PIC16C63A/65B/73B/74B Data Sheet Errata

The PIC16C63A/65B/73B/74B parts you have received conform functionally to the Device Data Sheet (DS30605**C**), except for the anomalies described below.

In the Device Data Sheet (DS30605**C**), the following clarifications and corrections should be noted.

FIGURE 10-1: SSP BLOCK DIAGRAM (SPI MODE)

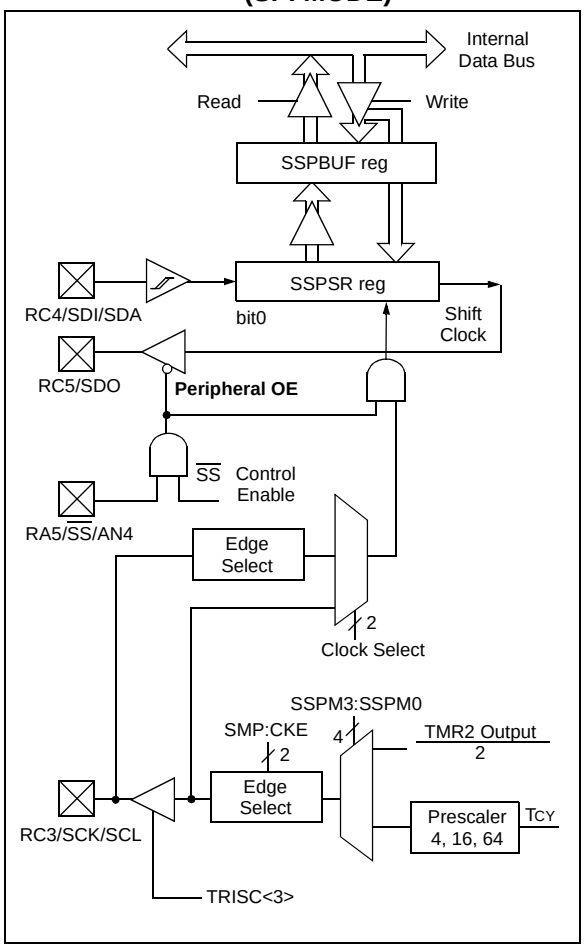
1. Module: SSP (SPI™ Mode)

In Section 10.2 (“SPI Mode”), Figure 10-1 and the note box immediately beneath it have been amended to better demonstrate the Peripheral OE line of the SSP module and describe its relationship to the TRISC<5> bit of PORTC.

3: **When the SPI is in Slave mode with SS pin control enabled (SSPCON<3:0> = 0100), the state of the SS pin can affect the state read back from the TRISC<5> bit. The Peripheral OE signal from the SSP module into PORTC, controls the state that is read back from the TRISC<5> bit (see Section 5.3 for information on PORTC). If Read-Modify-Write instructions, such as BSF, are performed on the TRISC register while the SS pin is high, this will cause the TRISC<5> bit to be set, thus disabling the SDO output.**

FIGURE 1: PINOUT DIAGRAM FOR PIC16C63A AND PIC16C73B, 28-PIN QFN

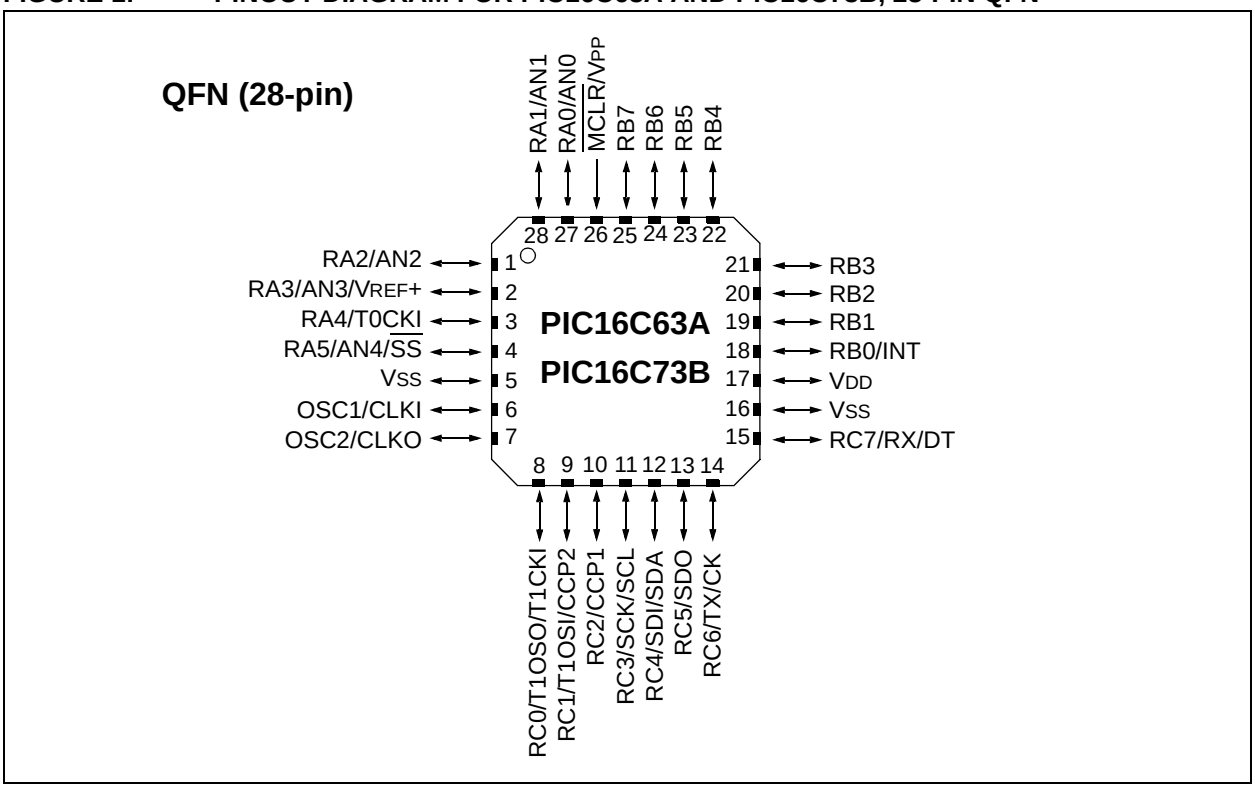
2. Module: Packaging (Pinout and Product Identification)

PIC16C63A and PIC16C73B devices are now offered in 28-pin near chip-scale micro lead frame packages (commonly known as “QFN”). This packaging type has been added to the product line since the latest revision of the Device Data Sheet.

1. The “Pin Diagram” on page 2 of the Data Sheet is amended with the addition of the 28-pin QFN pinout, shown in Figure 1.
2. Table 3-1 of Section 3.0 (“Architectural Overview”) is replaced with an updated version that adds a column for QFN pin assignments. All new information is indicated in **bold**.
3. Section 18.1 (“Package Marking Information”) is amended to include a marking template and example for 28-pin QFN devices. These are shown in Figure 2.
4. Section 18.0 (“Package Information”) is amended to include the mechanical drawings of the 28-pin QFN package. These are shown in Figure 3 and Figure 4, respectively.
5. Table B-1 (“Device Differences”) is amended to include the 28-pin QFN for the PIC16C63A and PIC16C73B devices.

FIGURE 2: PACKAGE MARKING TEMPLATE FOR PIC16C63A AND PIC16C73B, 28-PIN QFN

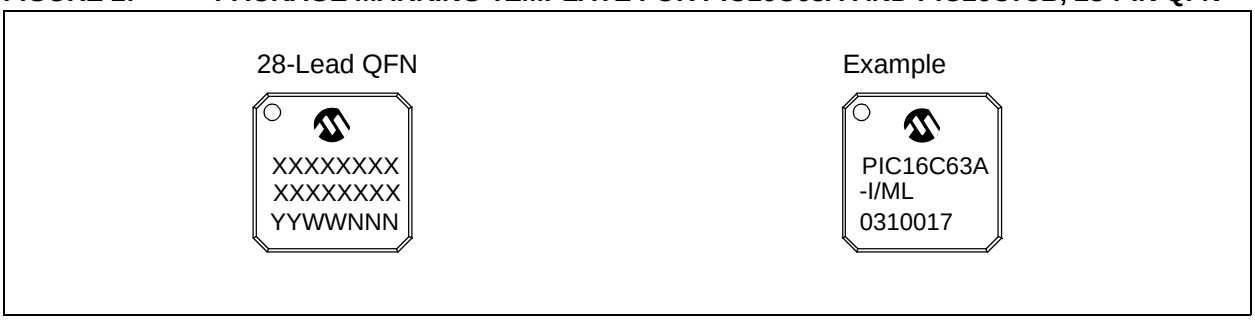
The addition of this option requires the following additions to the Device Data Sheet. The referenced figures and tables follow this text.

FIGURE 5: $\overline{MCLR}$ EXTERNAL CIRCUIT

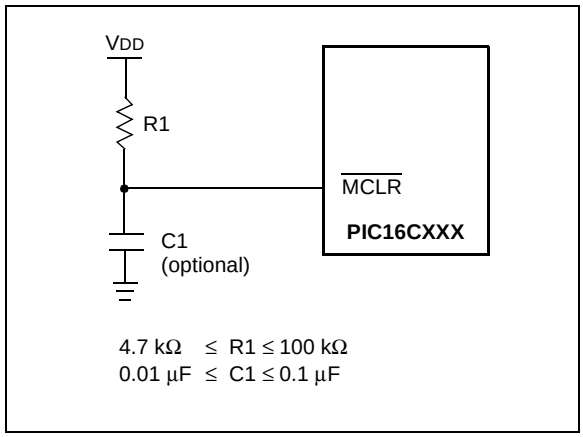
Section 13.4.1 (“POWER-ON RESET (POR)”) has been amended to clarify the minimum specifications required for $\overline{MCLR}$ in order to RESET the PIC16CXXX. The following paragraphs and figure have been added:

If a $\overline{MCLR}$ pulse occurs that is less that the minimum specification (parameter #30), improper device operation can occur.

If the minimum specification cannot be met, then an external circuit must be used to ensure that any pulse width less than the specification will be filtered before it reaches the $\overline{MCLR}$ pin.

A possible circuit to remedy this is shown in Figure 5. This circuit works by delaying the $\overline{MCLR}$ release following a power-up. If no delay is required, the capacitor may be omitted.

An alternative would be to use a supervisory circuit to control $\overline{MCLR}$.

Design validation should be performed to verify that the application works as expected.
